Mt Keith Nickel Project: Tailings storage upgrade

Western Mining Corporation Limited

**Report and recommendations
of the Environmental Protection Authority**

**Environmental Protection Authority
Perth, Western Australia
Bulletin 812
April 1996**

Figure 2. Environmental attributes adjacent to the TSF. (Source: WMC, 1996)

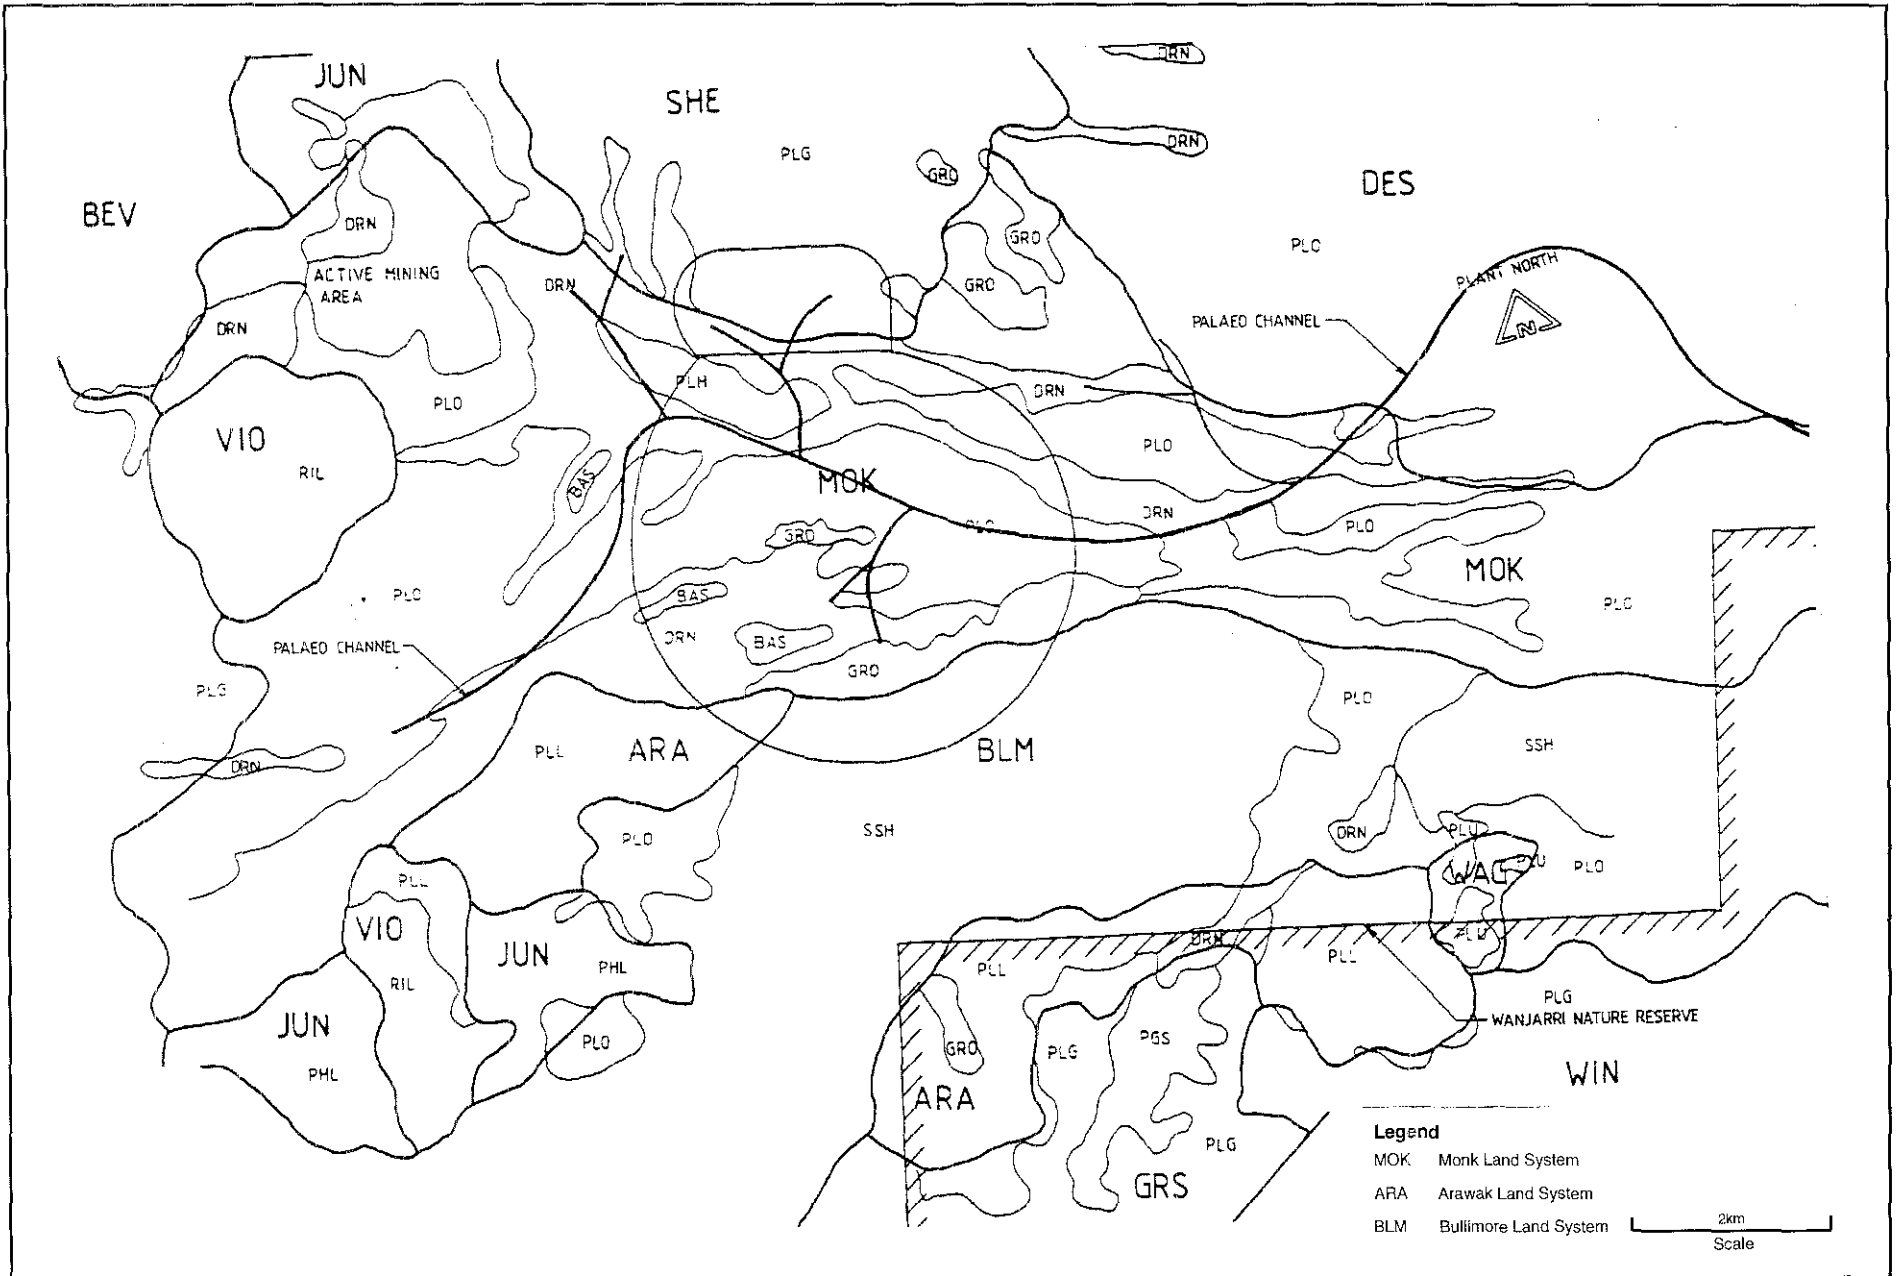
The proposal would directly affect three land systems represented within the region, and offsite impacts could potentially impact on other land systems. These systems are shown in Figure 2.

Construction of the tailings storage facility would result in direct disturbance to the Monk, Bullimore and Ararak land systems, as shown in Figure 2. Other land systems are located within a few kilometres of the TSF and could potentially be indirectly affected by its construction.
